Hill roads and sporting estates – the Glen Banchor/Pitmain “forestry” bypass is back

The differences between the current and the previous application

Brown line shows line of road in previous application, the blue between the two red lines the current application. The woodland plan, accompanying the application, shows a different line for the forestry road and I have marked this (approximately) in yellow.

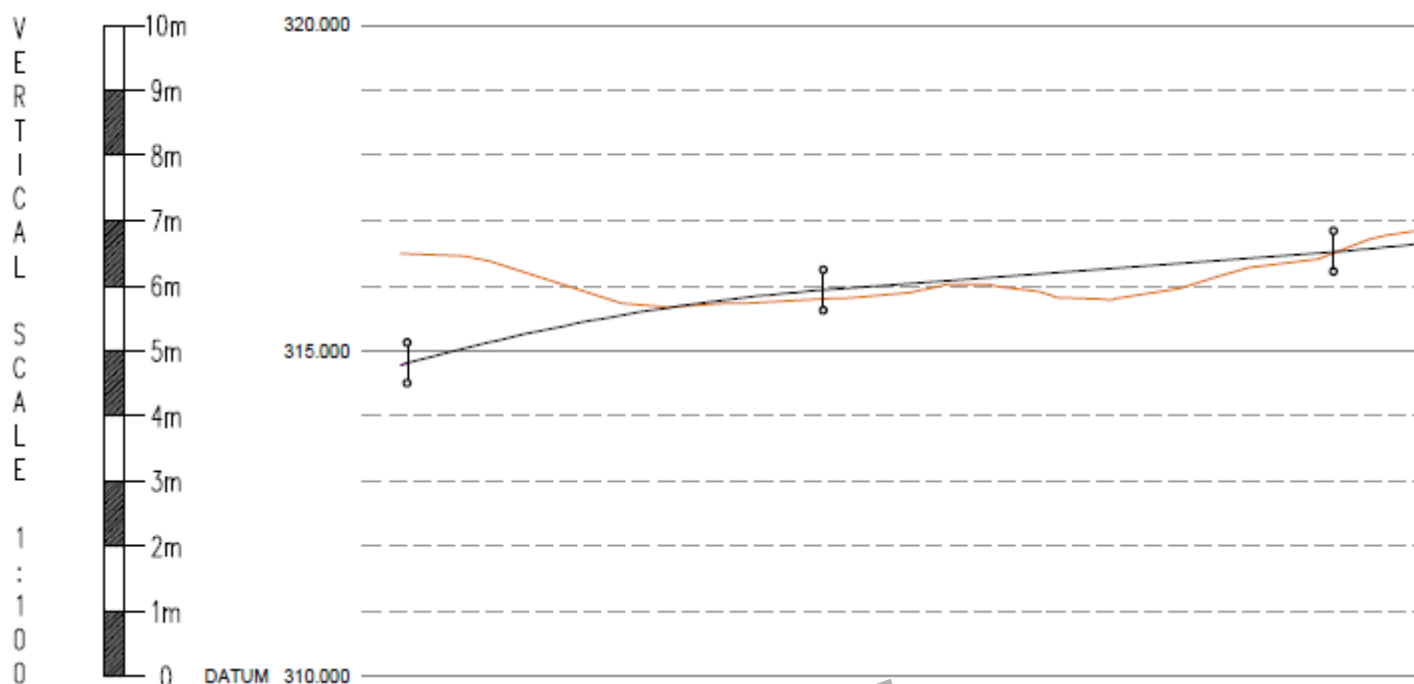
The main difference between the new application ([see here](#) for planning papers) and the previous one is the line taken by the proposed road, described in the application form as a “revised location”. The proposed road now follows a lower route round the hill, presumably following advice from CNPA planning officers that if the estate really wanted to press ahead with a planning application this could reduce its visual impact.

The other main difference that I have been able to establish – there is no clear statement of the differences in the planning documents – is the number of borrow pits. These have been reduced from several to one by dint of using bulldozed material from excavated sections to fill in dips in the ground.

Extract from Long Section, the brown line shows the ground as it currently is, the black line the level road will be “smoothed”.

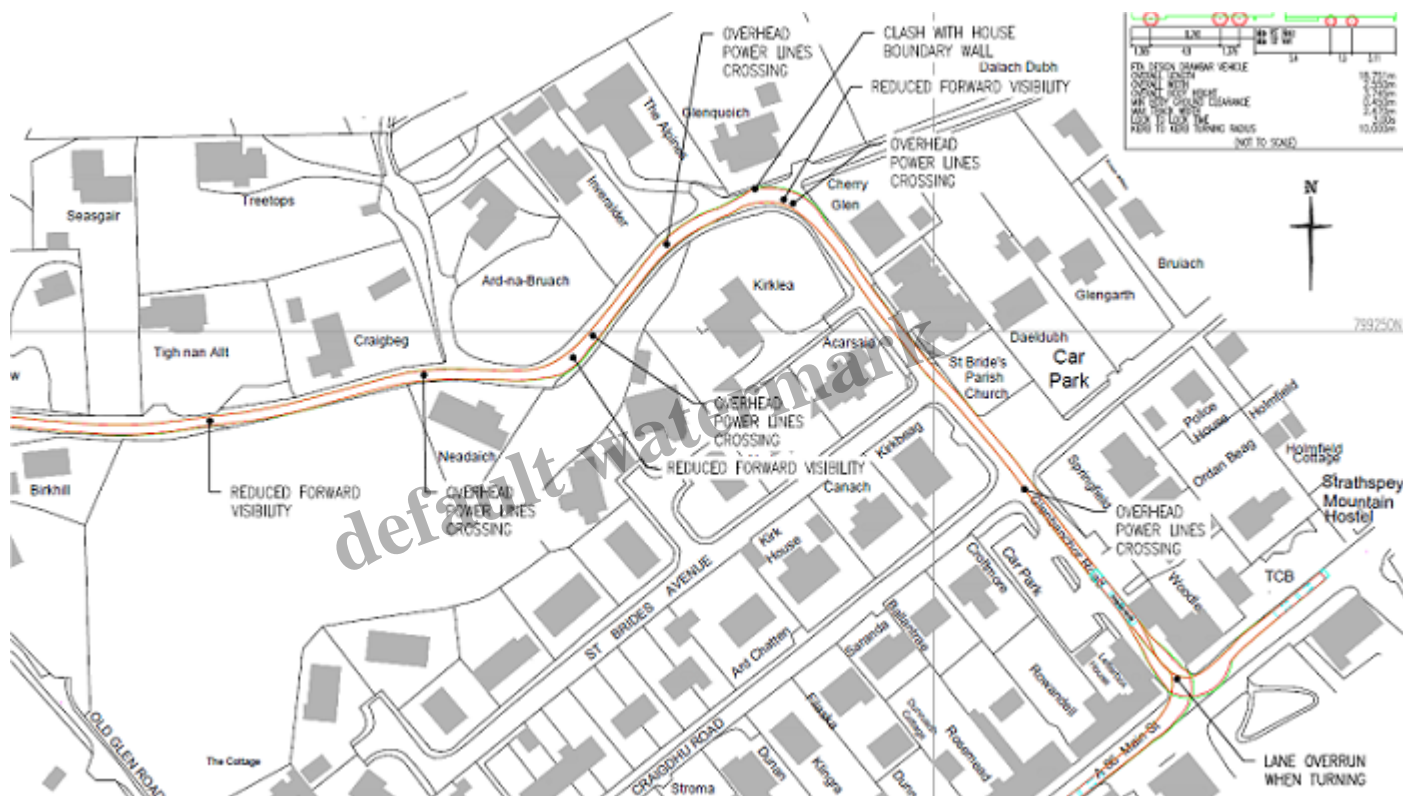
Besides these two differences, there are many more documents than there were in the previous application. All of which date from when that application was still being discussed with the CNPA and may well have been provided as a result of their advice. These include a “Swept path analysis” – jargon for a road survey – visualisations of the proposed route, a peat survey and the Supporting Statement. Essentially, however, it is the same application and has been justified for the same reasons, that the road is necessary for forestry purposes.

“Swept analysis” for first part of Glen Rd which runs from the Main Road in Newtonmore up into Glen Banchor

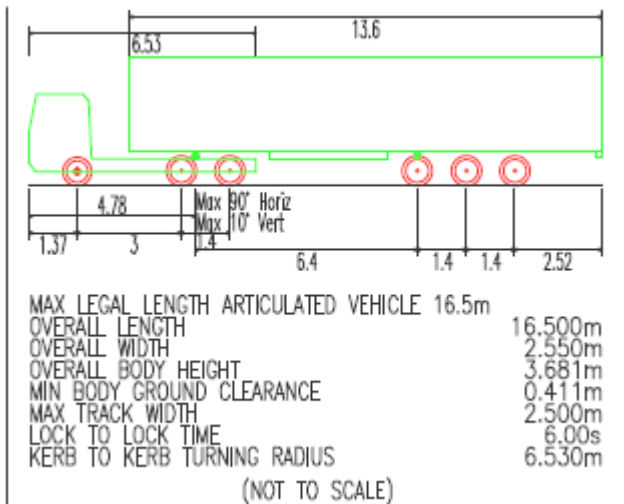
The inclusion of a number of “Swept Analyses” of Glen Rd in the new application, annotated with comments like “Reduced Forward Visibility” and “overhead power lines crossing” are meaningless without an analysis of how this would effect timber extraction. For example, the Electricity Supply Regulations ([see here](#)) set a minimum height for overhead powerlines crossing roads of well over 5m which is significantly greater than the height of the lorries included in the analyses:

If full-size bin lorries can use the road safely at present – I have seen them – why couldn't smaller timber lorries do the same? The supporting documents avoid this question because it undermines the ostensible rationale behind the application.

Annotations in bold capitals

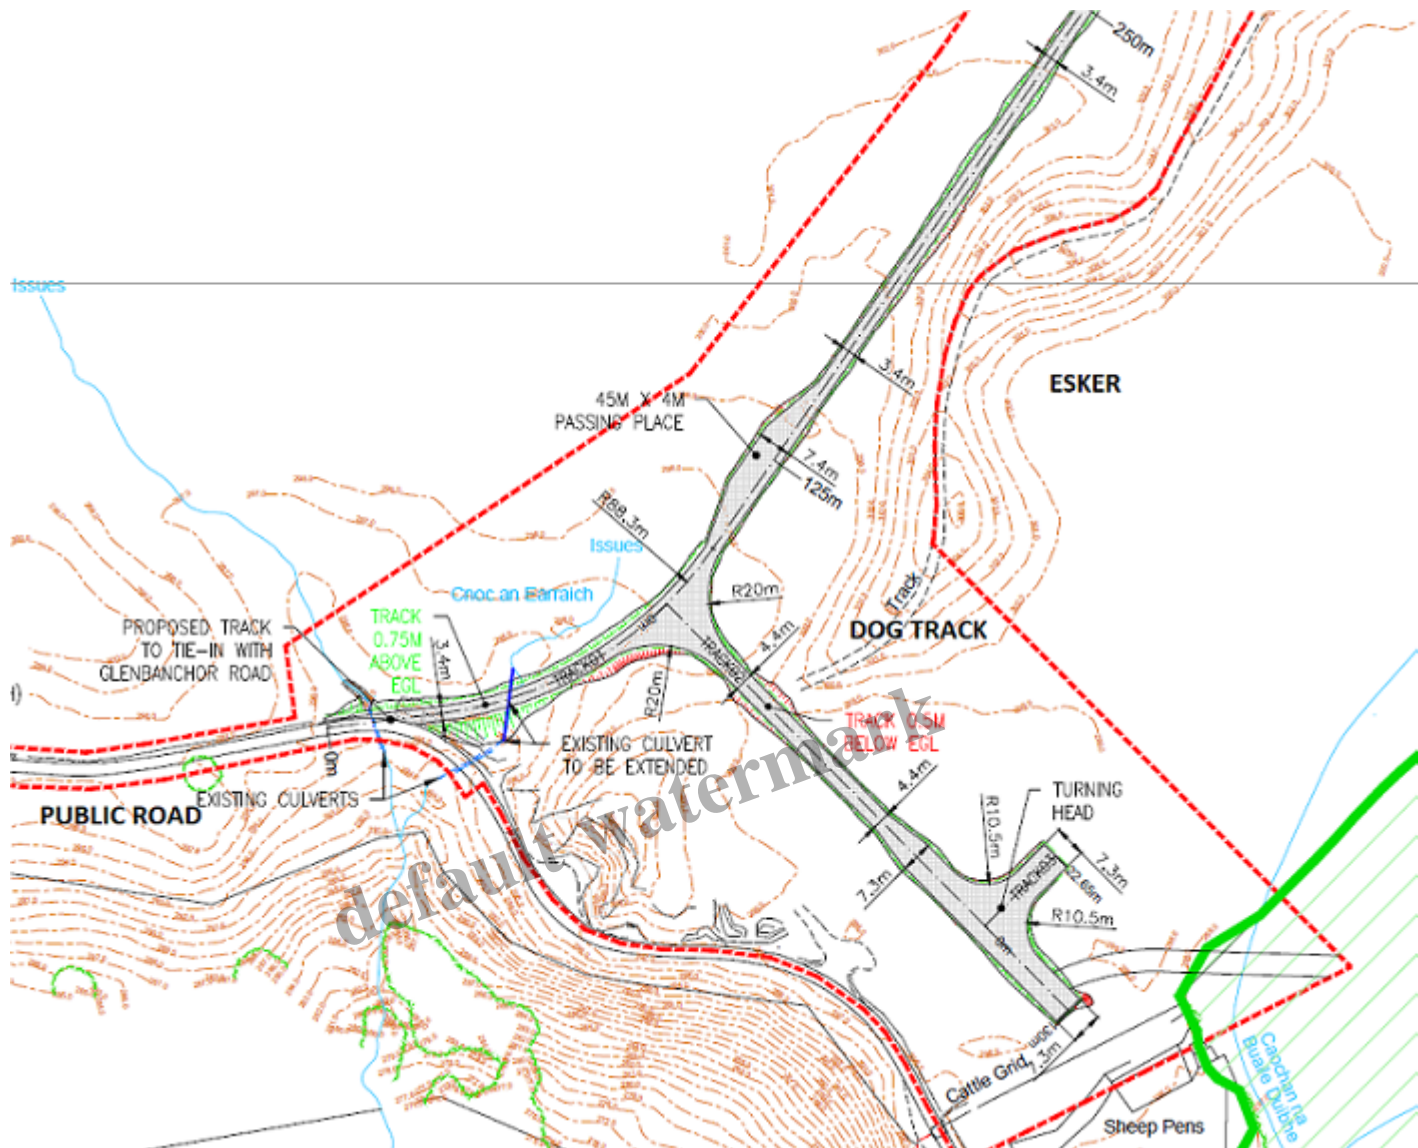
The maps in the application are a better source for evaluating the landscape impact of the new road network. Below is the map showing where the new road would connect with the public road in Glen Banchor, together with a connecting branch to the windthrown plantation to the south:

Note the 45 x 4m passing place, one circa every 200m along the road, and the “turning head”. None of this is evident from the visualisations. The two roads in parallel, one on top and one below the esker, shows just how little regard the Pitmain Estate and the consultants who work for them have for the Scottish landscape.

The green hash marks embankments, the blue the drainage ditches.

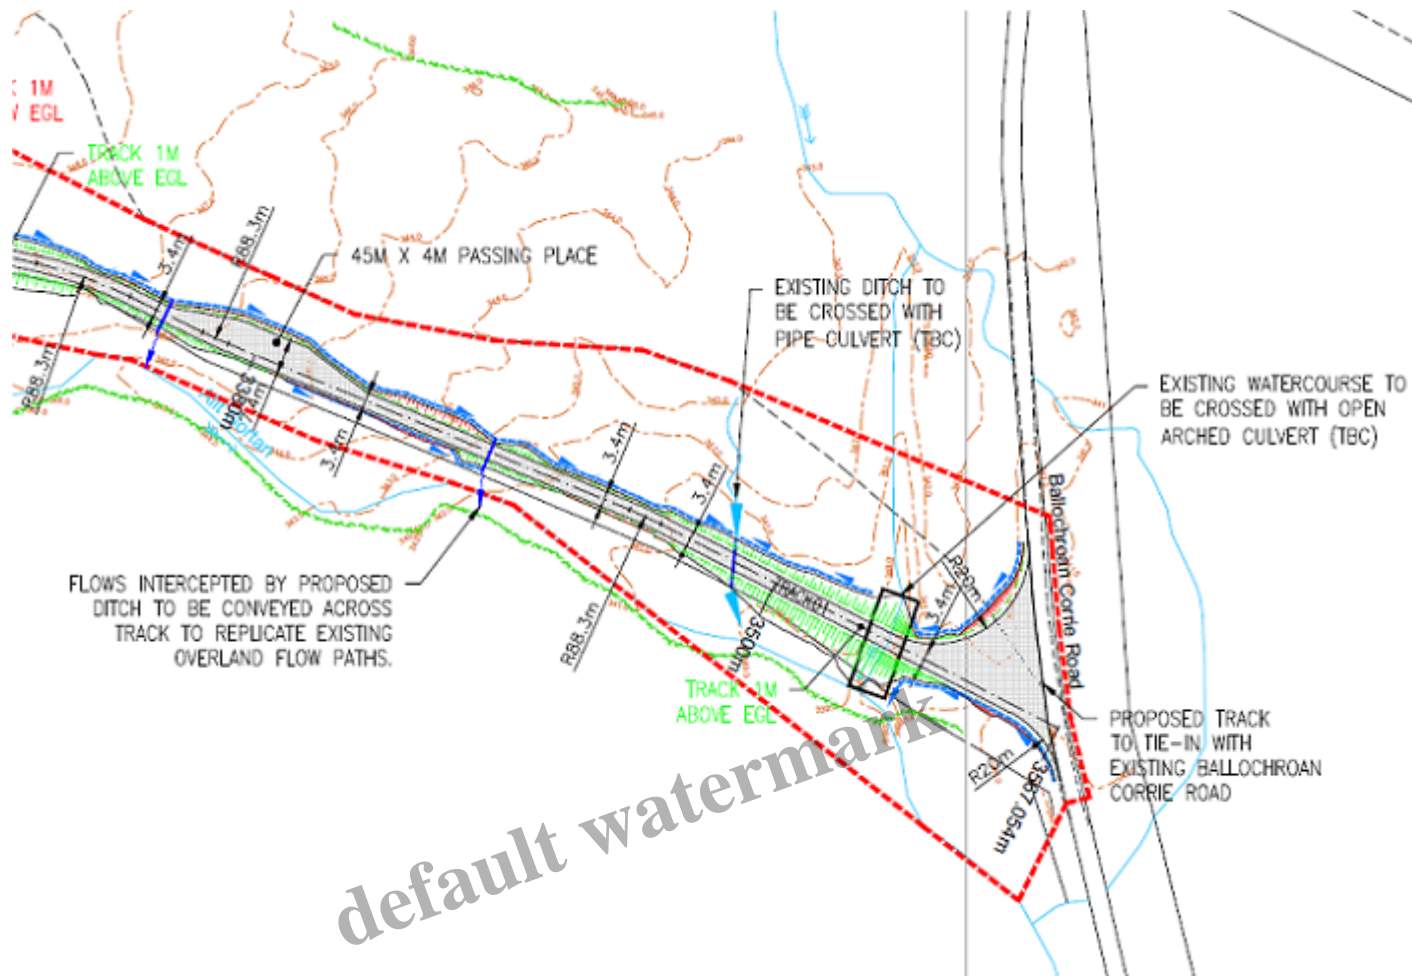
The suburbanisation of the landscape and another indication of the real purpose of the road is also evident at the other end where it meets the Ballachroan Road:

Why the need for a junction opening 20m wide? And why does this also face both ways if the purpose is for timber lorries coming from below (the bottom of the photo)? It appears the owners of the Pitmain Estate, their staff and guests want to be able to get to places fast (hence too all the passing places).

Section close to the junction with the Strone Rd: the red shows a cutting, the green an embankment (which will be covered by a "rock blanket") and the purple a retaining wall.

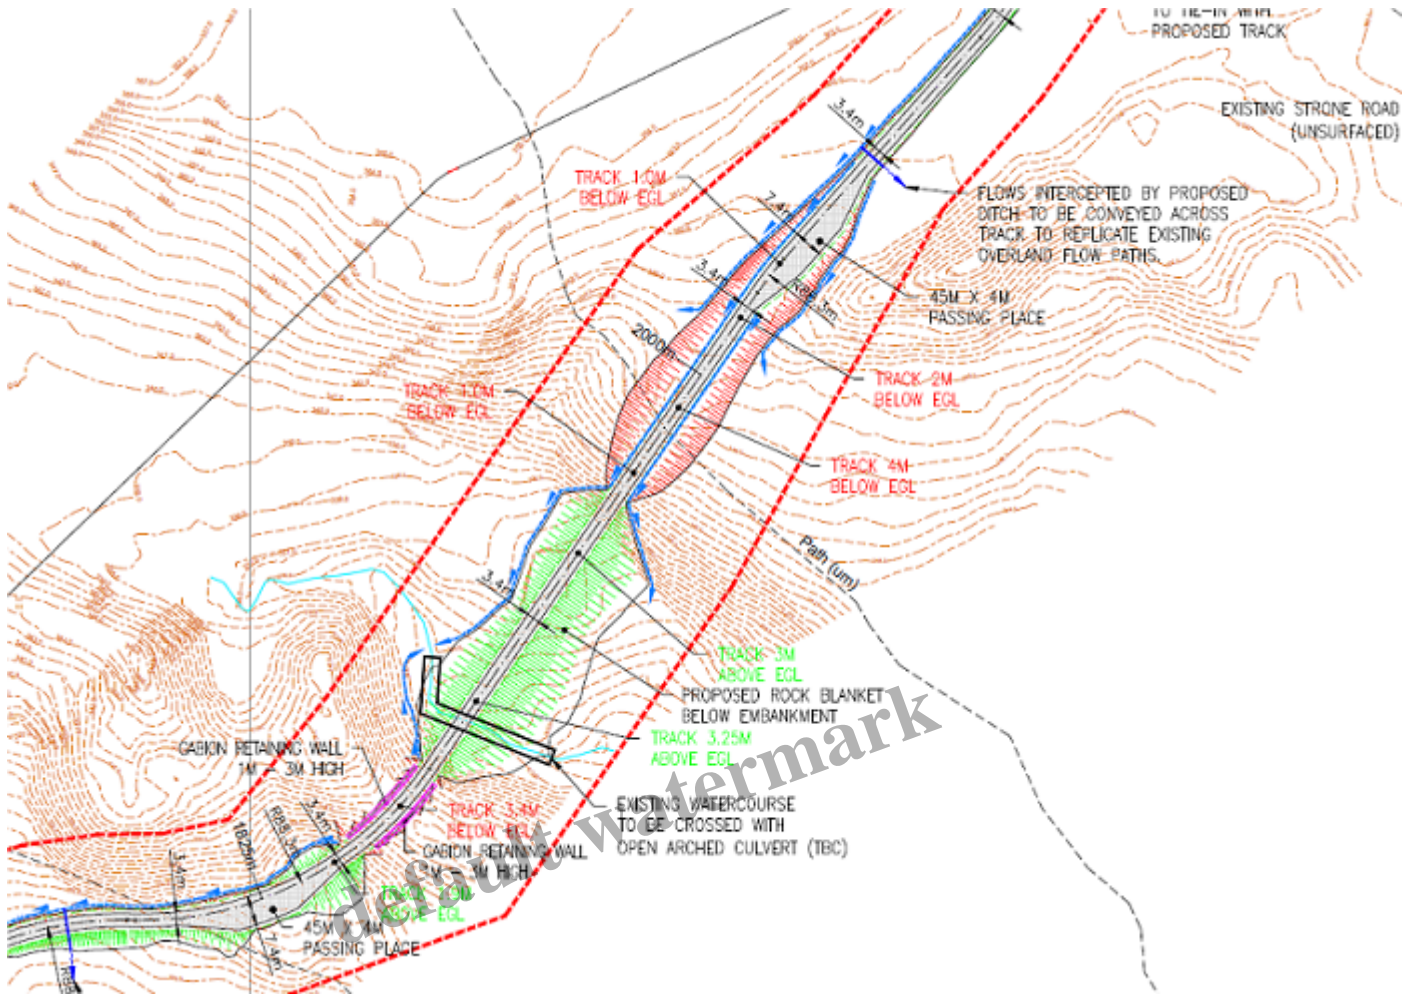
From a landscape perspective, the application fails to assess the impact of the cuttings and embankments which are shown in the plans:

The Design Statement claims that the road construction is in accordance with SNH guidance on “Constructed tracks in the uplands” ([see here](#)). A cursory glance at that guidance, which starts by suggesting alternatives- like the public road in Glen Banchor! – should be examined before deciding to build new roads, shows that this is not the case. There is even a diagram (page 35) advising that roads should not be constructed in straight lines up slopes as is proposed above!

Following a direct route will require cutting and rock exposures. The straightness of the route is likely to conflict with the chaotic nature of this landscape

Note that with the verges and ditches the proposed road will impact an area 7 metres wide (and far more where there are passing places)

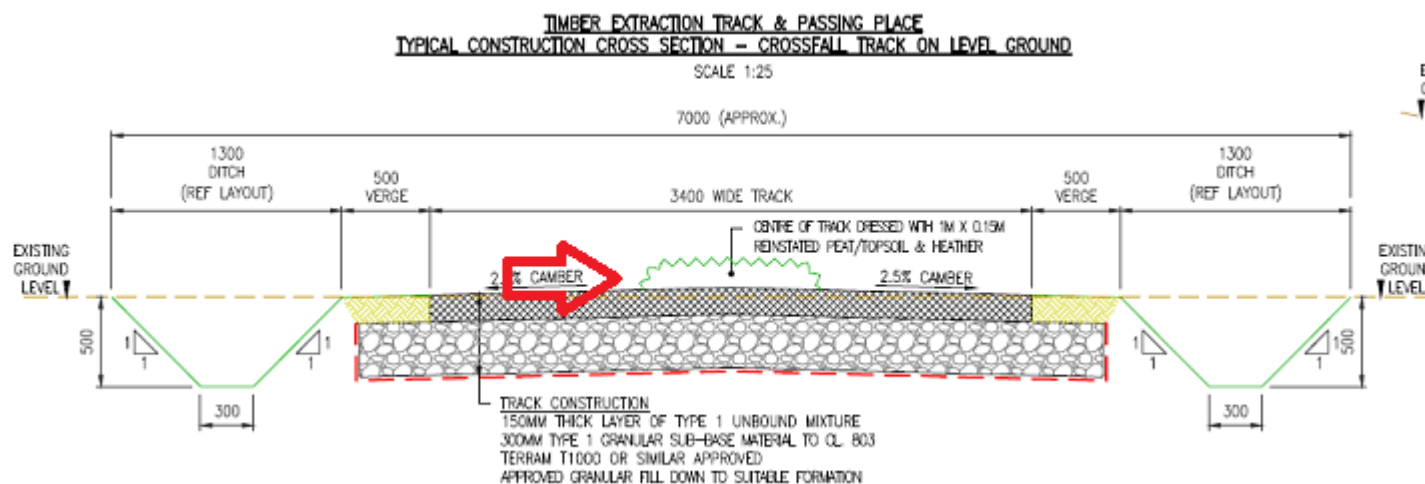
While also not clearly stated in the Design Statement, it appears from the diagrams that the Pitmain Estate is proposing to use some of the "surplus" peat from the road construction to create a vegetated strip down the middle of the road:

While vegetated strips down hill roads are generally welcome, re-using peat to create them will destroy that peat and will be like using peat as garden compost. Peat is created and develops in water-logged conditions but the centre of the track is well drained so any water that is in the peat will drain out the sides. This peat will therefore quickly degrade releasing carbon into the atmosphere.
